TECHNICAL NOTE – RESPONSE TO LEAD LOCAL FLOOD AUTHORITY COMMENTS

**PROPOSED EMPLOYMENT DEVELOPMENT
HORSEPOOL GRANGE, STANTON UNDER BARDON**

project number: ADC3968			report reference: ADC39682-RP-D	
version	date	author	reviewer	comments
1		Richard Winn		internal draft
2	13.07.26	Riley Male	Richard Winn	first issue

Existing Drainage Layout

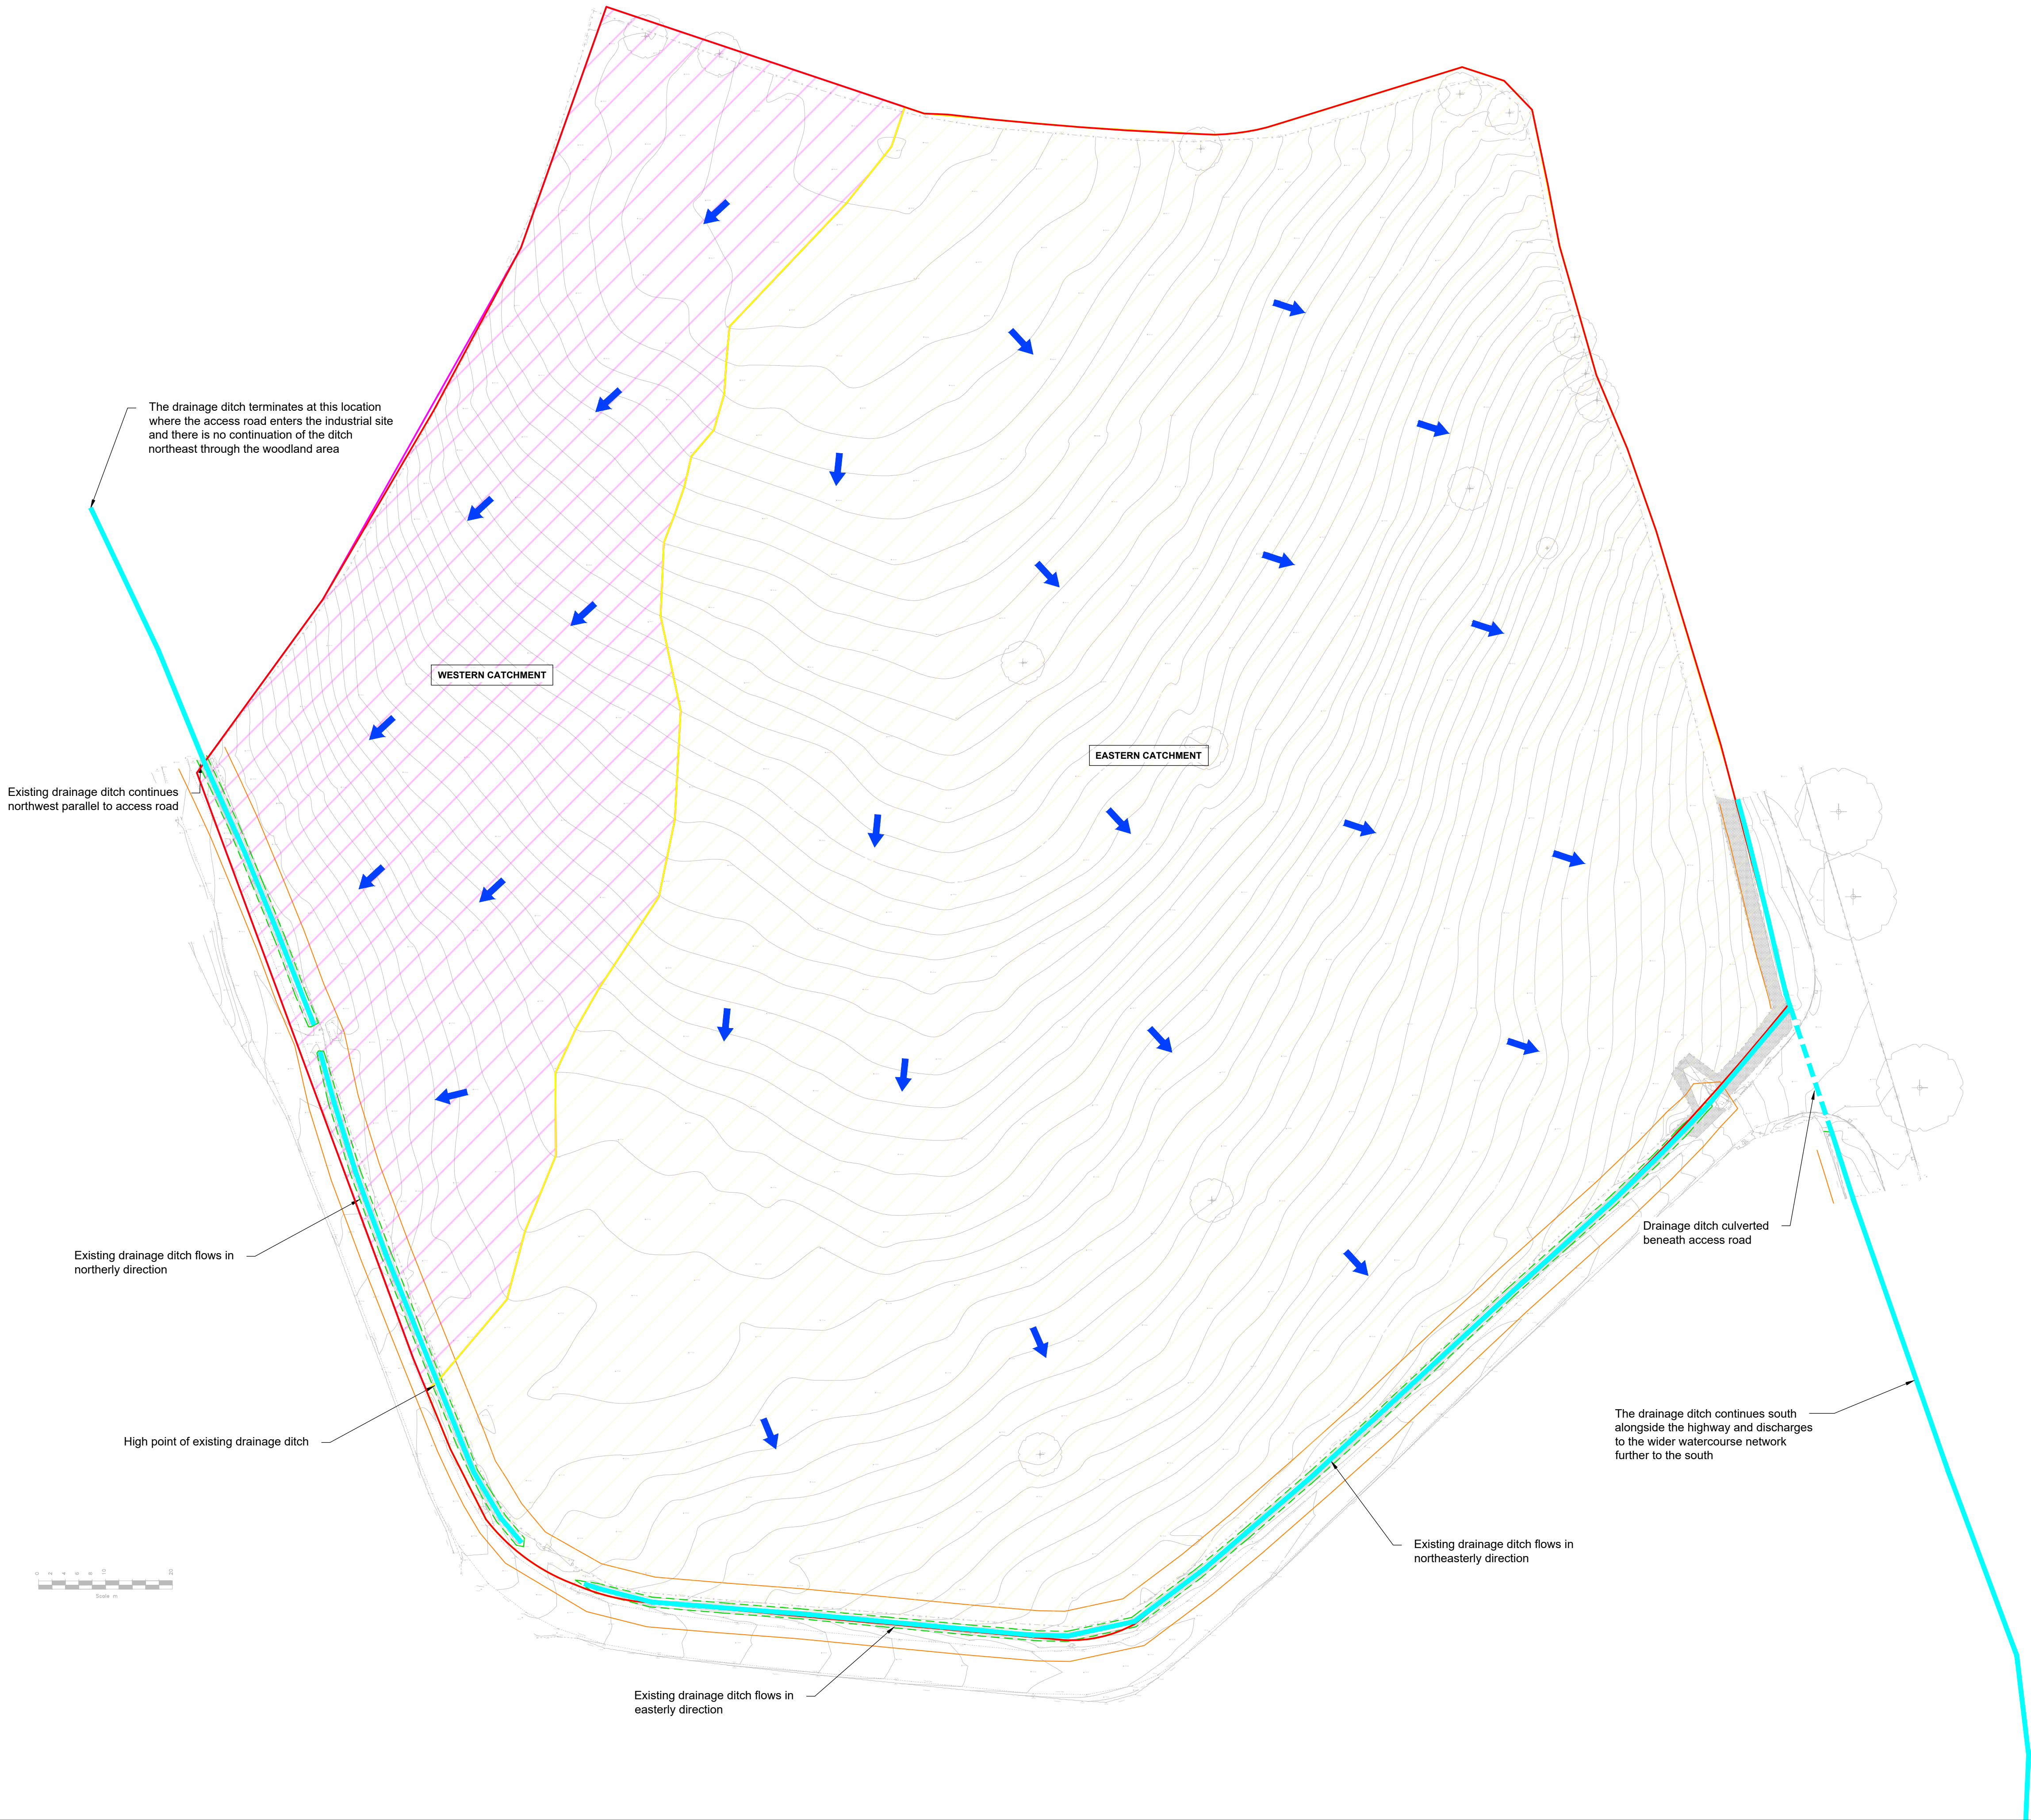
Given the topography part of the site currently drains to the west. The proposed drainage strategy currently looks to discharge all water post development to a watercourse south east of the site. As the water from the western site catchment does not currently drain in this direction this would involve catchment transfer of surface water. The LLFA request an existing drainage plan including

all drainage features for the pre-development site, overland flow routing and off-site relevant receptors (including downstream connectivity) to understand where the water currently drains to. The developer should look to discharge water in a way to mimic the current drainage regime on site. Full consideration of draining the sites water to its current flow path needs to be completed. The developer needs to demonstrate fully that an outfall to the west for that sub catchment is not possible, and only then can alternative outfalls be considered for the site, if demonstrated to not increase offsite flood risk.

- 2.1 The LLFA has requested an existing drainage drawing showing all drainage features for the pre-development site, overland flow routing and off-site relevant receptors (including downstream connectivity) to understand where the water currently drains.

- 2.2 The existing drainage layout drawing (**Appendix B**) shows the existing drainage features on the site which comprise a continuous ditch on the eastern, southern and western boundaries. The whole site area sheds towards the ditch from the high point on the northern boundary.

- 2.3 The high point of the ditch is in the southwest (identified on the existing drainage layout drawing) and this effectively splits the site into two catchment areas. The western catchment drains to the section of ditch that flows northwest towards the existing industrial area. This section of ditch was observed during the site walkover and was found to continue up to the gateway into the industrial estate (Figure 1). At the boundary of the industrial estate the ditch was found to stop abruptly and there was no onward continuation of the ditch along the boundary of the industrial area (Figure 2), therefore it is assumed that any flows within the ditch would spill over the top of bank and overflow into the industrial estate. This flow regime is inline with the flow routing shown on the Risk of Surface Water Flooding on the Flood Map for Planning, which shows overland flow paths heading east around the industrial area buildings and on land further to the south. There is no known ditch network in these areas to route the flows.

- 2.5 Therefore, due to the lack of suitable downstream connectivity of the drainage ditch network in the west, and it is considered appropriate to discharge the full extent of the proposed development drainage system to the existing outfall in the east, as this outfall route has confirmed connectivity to the mapped watercourse system further to the south. In any event the two catchments for the wider area combine at the confluence of the mapped watercourses approximately 1700m to the south of the site upstream of the watercourse crossing beneath Markfield Road and continuing towards Thornton Reservoir.
